FINAL
Environmental Impact Report

**1145 Market Street
Office Building**

October 20, 1983

● Figure No. 9A

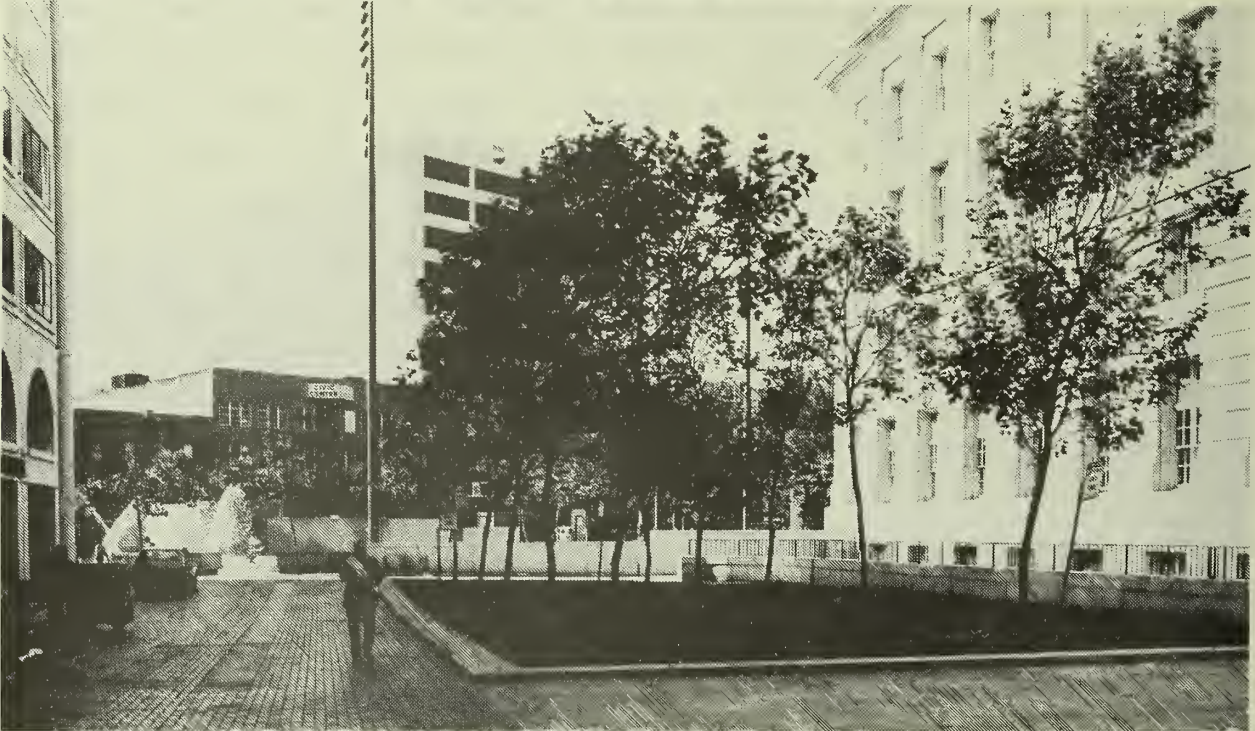
COMMENT

Photographs of plaza areas on Fulton Street and Leavenworth Street near the United Nations Plaza fountain are shown on Figure 9A. Figure 2, Project Location Map, page 8 depicts the Plaza areas surrounding the Federal Office Building, Bay Heritage Building, and Orpheum Theatre opposite the project site.

"Figure 9A, page 18A shows the Fulton and Leavenworth Street plaza area near the United Nations Plaza fountain. Vehicle use of Fulton and Leavenworth Streets terminate at Hyde and McAllister Streets, respectively, at which point they become public plaza areas that eventually join the United Nations Plaza.

Figure No. 8A

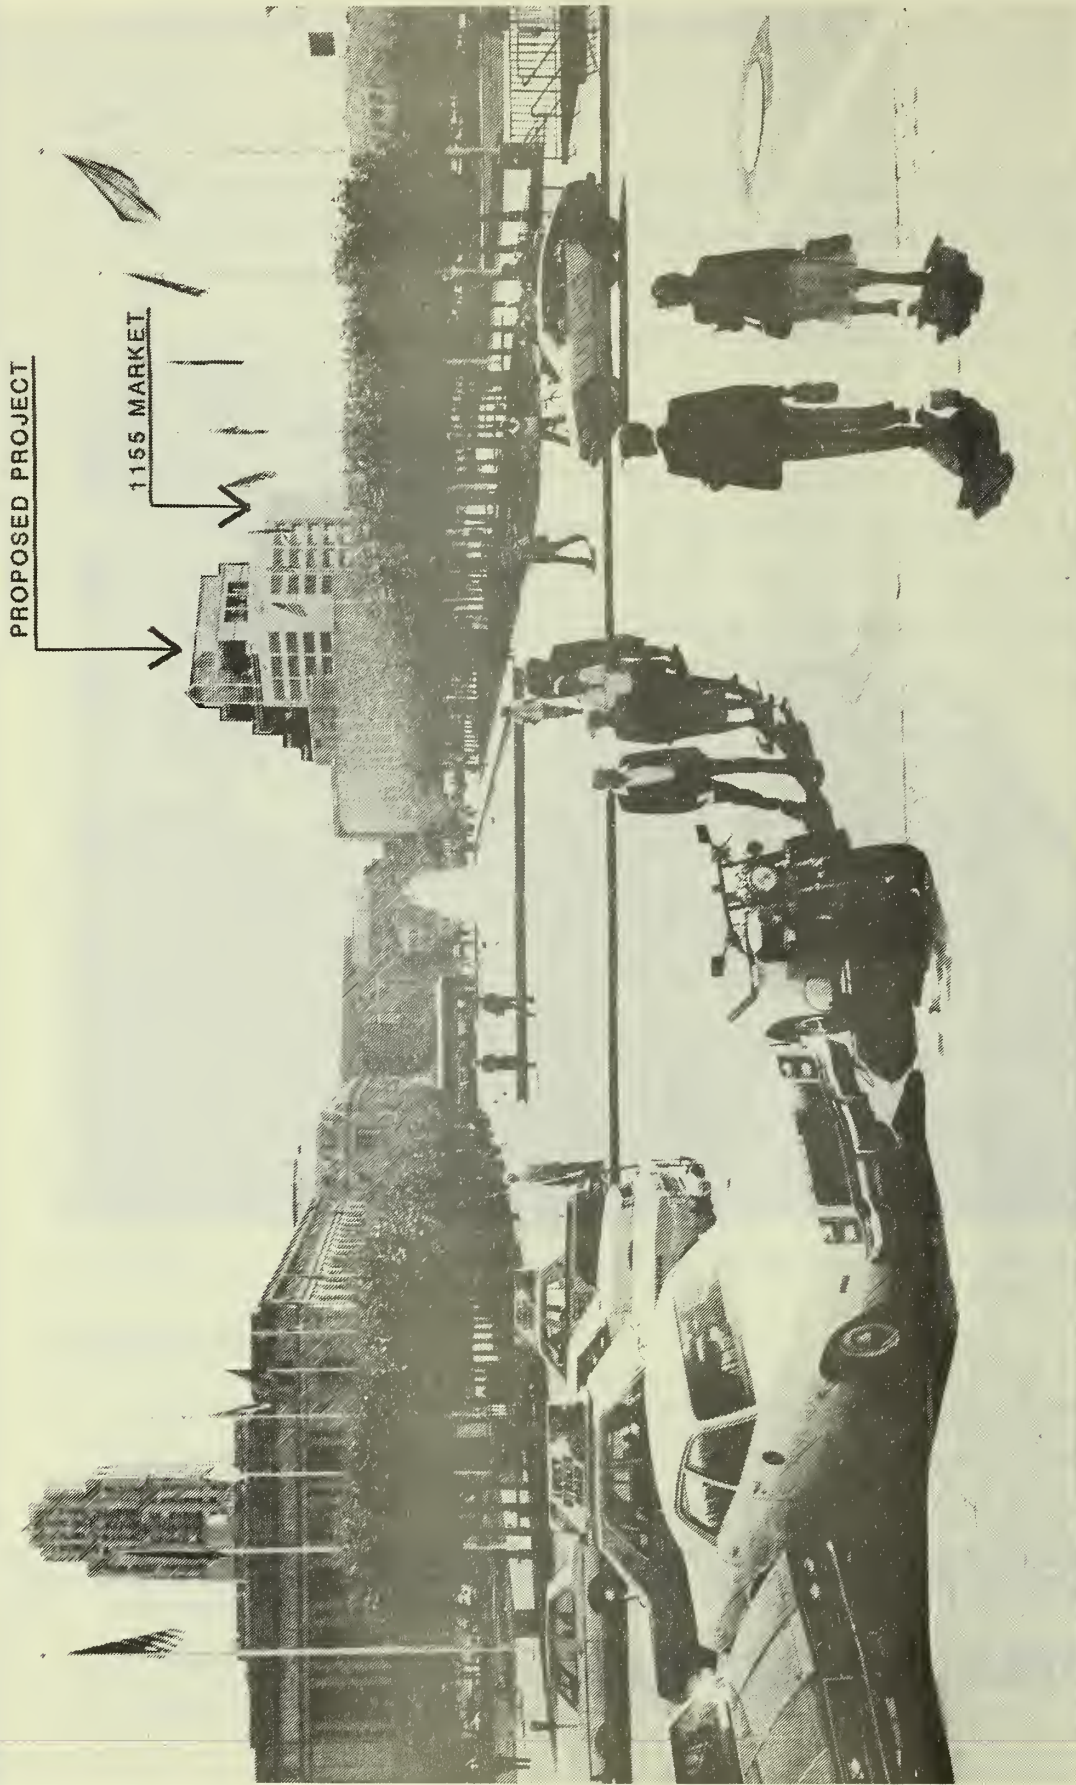
"A photograph of the Federal Building, Bay Heritage Building and United Nations Plaza is shown on Figure 8A, page 16A."

A photomontage of the proposed project as would be viewed from the Polk Street steps of City Hall is provided on Figure R-1.

R-2

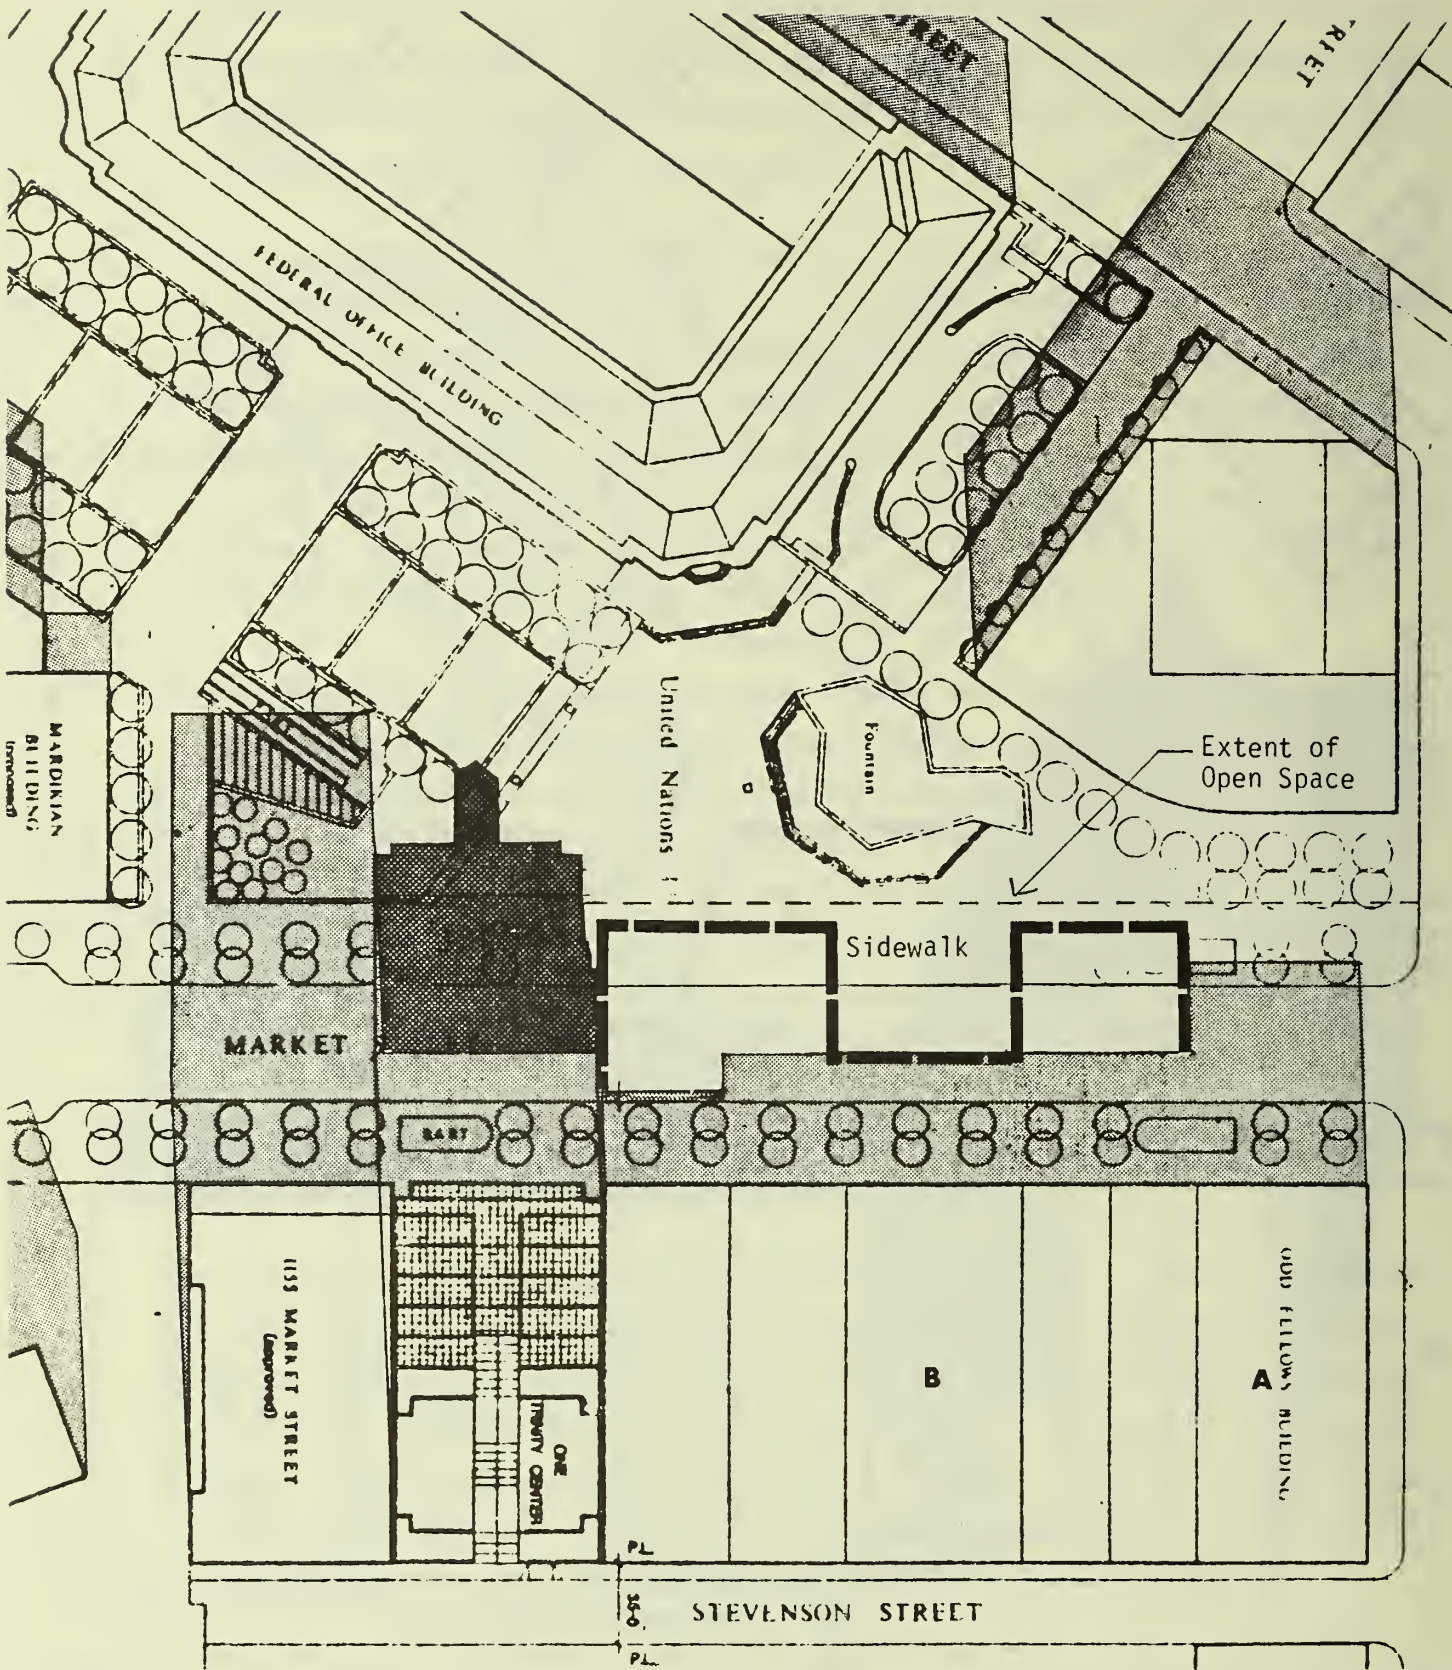
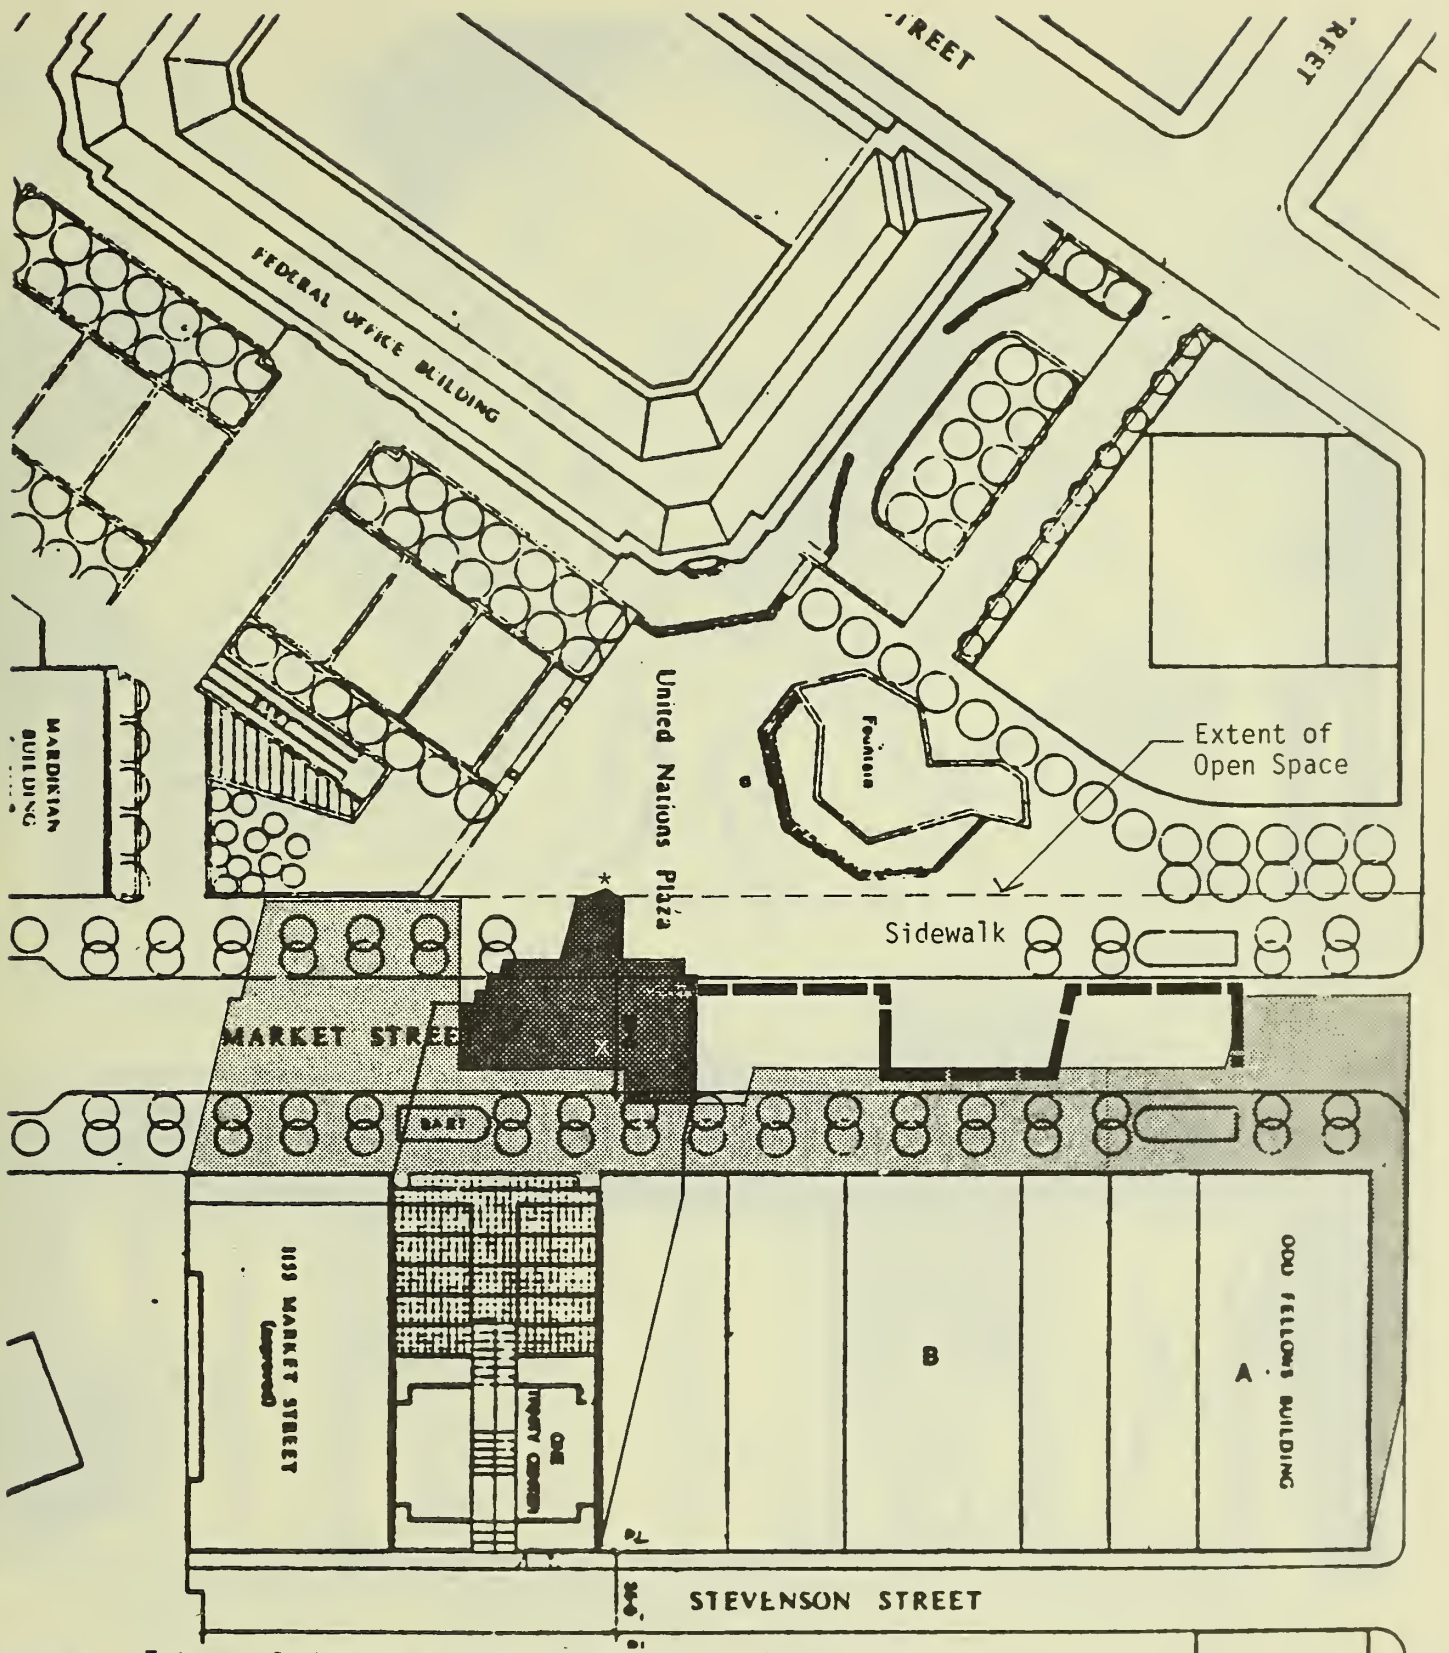
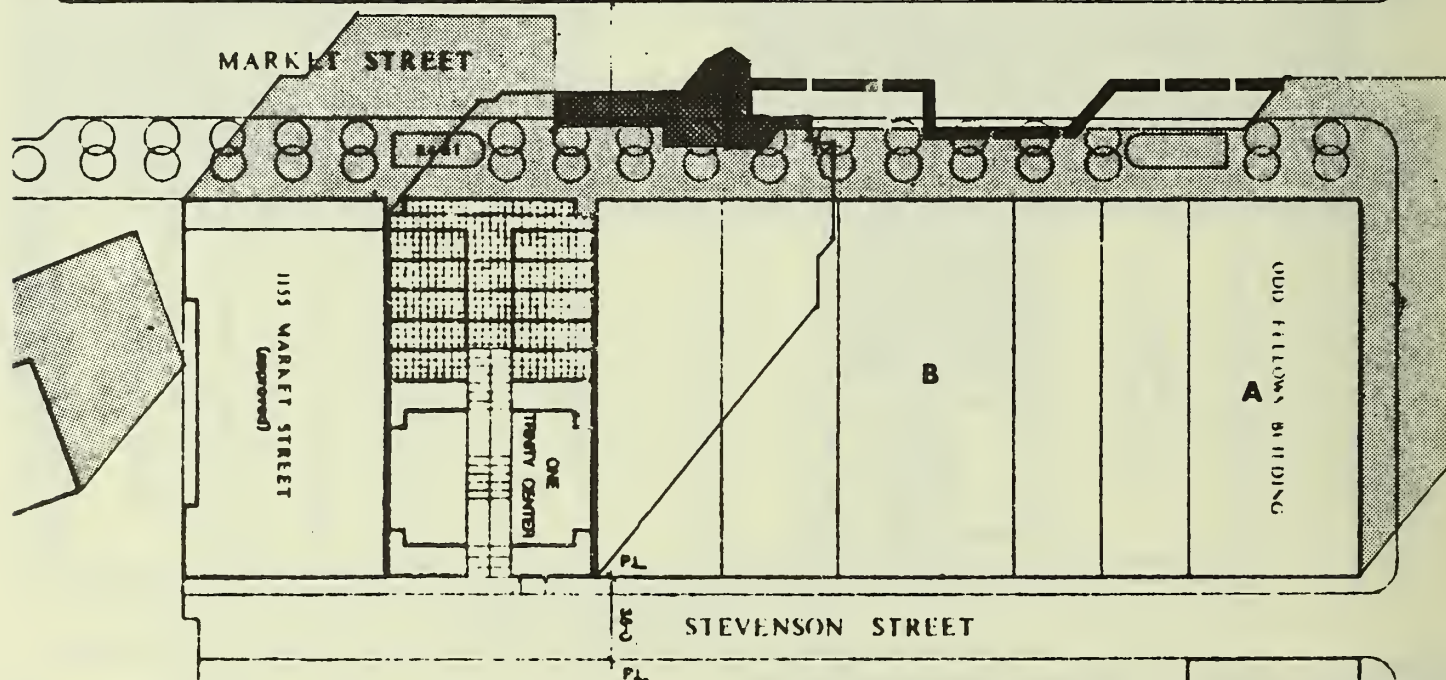
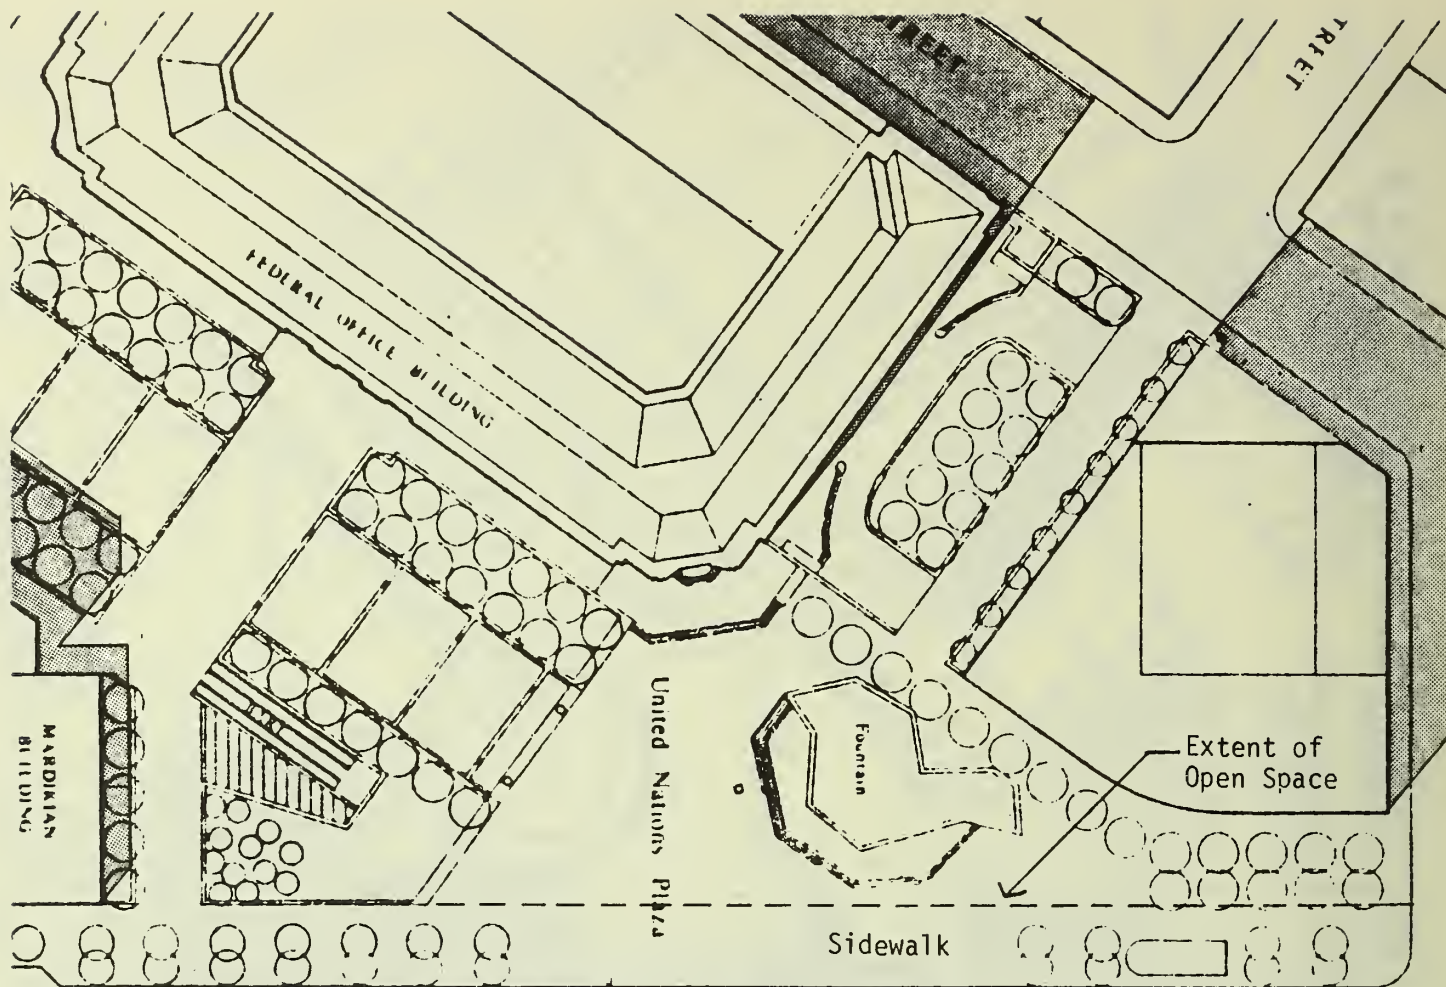
RESPONSE

The shadow analysis for the project was prepared as part of the Initial Study and Preliminary Negative Declaration issued by the Department of City Planning on May 21, 1982. The Initial Study is included as Appendix A of the EIR. On September 2, 1982, the Commission determined that an EIR was required on the proposed project providing further impact analysis for growth inducement cumulative transportation and cumulative air quality impacts; shadows were not identified as a potentially significant impact.

The shadow analysis indicates that the project would cast a shadow (assuming sunshine every day of the year) beyond the north curb of Market Street after 10:00 a.m. for about 200 days a year for about one and one-half to two hours on each morning during the months of January through March, September through December. The project would, in conjunction with other projects in the area, shadow a portion of the United Nations Plaza Fountain about 60 days a year for about one and one-half to two hours each day during the months of November through January. Although not precisely indicative of cloudiness conditions in San Francisco, it is noted that cloudiness measurements taken at the San Francisco International Airport show that

Shadow studies for the project have been prepared by Peter Bosselmann of the UC Berkeley Environmental Simulation Laboratory (ESL), which appear as Figures R-2 through R-10 on pages 25-33 of this document. The study reflects sun shading concepts and criteria introduced in the ESL report, Sun and Light for Downtown San Francisco, April 1983, which have been incorporated into the Department of City Planning's proposal for the Downtown Plan, August 1983. As compared to the shadow studies originally prepared for the project that appear on pages A-49 through A-56 of the EIR, the Bosselmann study uses the most current methodology.
